Our ref: 12654086

Launceston Private Hospital – Traffic Response to Council Comments

- DA No. DA0377/2024, comments dated 30th September 2024;
- DA No. DA0379/2024, comments dated 1st October 2024
- DA No. DA0380/2024, comments dated 1st October 2024
- The subsequent City of Launceston email dated 15th October 2024, which supplement DA No. DA0379/2024.

Launceston Health Club
217-229 Wellington Street, Launceston
Medium Rigid Vehicle (MRV)
Site and Loading Bay Access
Ground Level

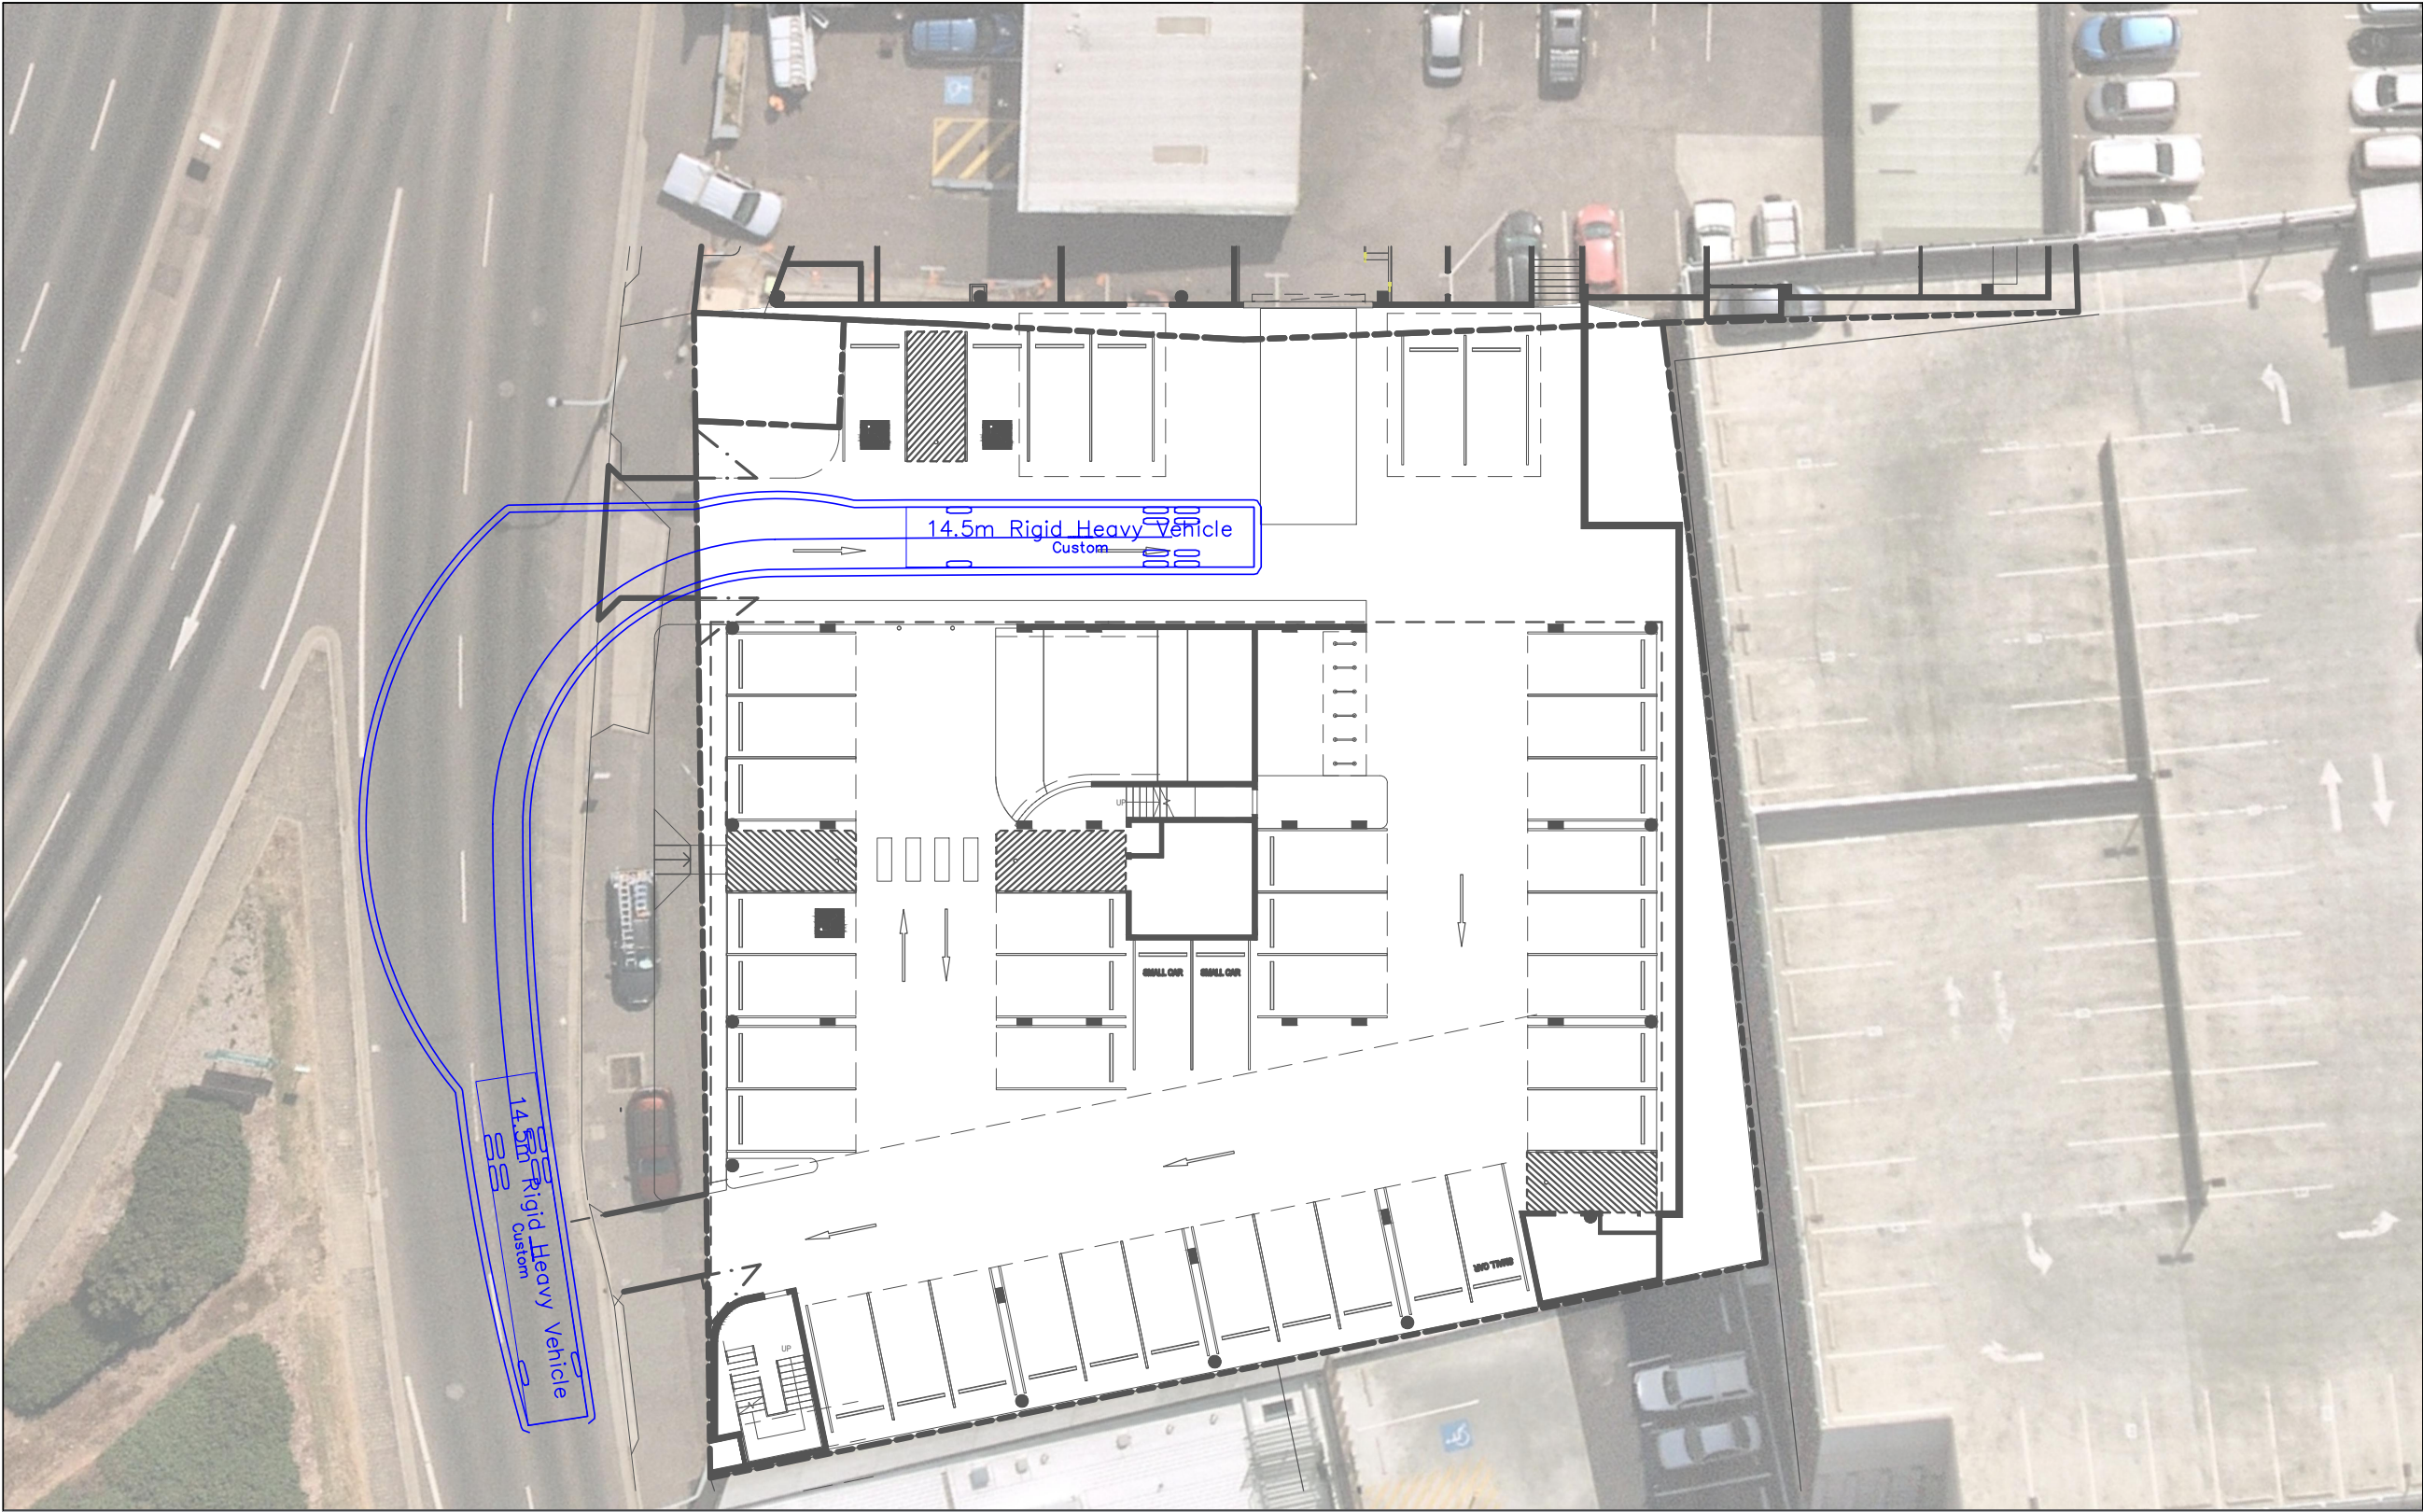
- *"Advice, having regard to the above, showing how the loading dock / entry driveway will operate, and how they will avoid conflicts between manoeuvring / exiting heavy vehicles and entering vehicles."*
- *"Advice to confirm that a Medium Rigid Vehicle is the largest vehicle that will need to access the site, for all stages of the Launceston Private Hospital development"*
- *"Confirmation that the sight distances for the entry driveway are acceptable for when heavy vehicles are exiting."*

- "Advise how the conflict between the Medium Rigid Vehicle swept path and the proposed column in the loading area can be resolved."
- "Address the manoeuvring into the down ramp at level 2 as shown in figure 4 and obstructed sight lines and potential conflict between vehicles coming up the ramp to level 2 and vehicles turning to go down the ramp."
- "Address advisory signage regarding location of motorcycle, bicycle and accessible parking."
- "Address possible consolidation of the two accessible parking spaces on level 3 to a single location adjacent to the lift lobby."

1. MRV's are unable to navigate through the one-way system and would be required to exit as shown in the referenced swept paths, which show the manoeuvre is achievable (refer movement 1 illustrated).

Where a vehicle has already entered the site when an MRV has only started to make its exit manoeuvre, there is enough space within the site to allow these vehicles to pass. Swept paths of this are provided within Attachment A to this letter.

- The column conflicting with the MRV swept path has been shifted to the north, such that this conflict no longer exists. Please find updated swept paths within Attachment A to this letter.
- The following interventions have been applied within the level 2 car park design:
 - Line marking to guide vehicle movements around the curve, into the ramp.
 - Mirror for drivers on level 2 that provides visibility of any vehicles that are potentially on the ramp.
 - Stop line so that vehicles on level 2 stop to look and give way.
